# Annex 5: Customer declaration: HW change description v1.2 to Test Report 20-1-0017101T02a-C1

## 1 LOCU1xxx HW change description v1.2

Hardware change description  
SICK LOCU1xx – UWB TAG

v1r3 -> v1r3.1 change description

Details for changes of LOCU Battery Basic/Advanced bottom layer:

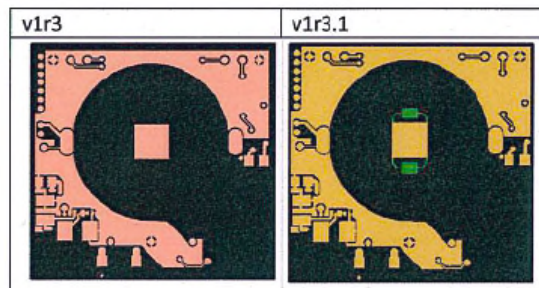
1. Battery holder: Pad adjustment of negative battery contact- milled grooves for battery holder are shifted in v1r3.1 comparing to v1r3. The pitch of grooves is increased by 0,45 mm.

- red mark - v1r3
- green mark - v1r3.1
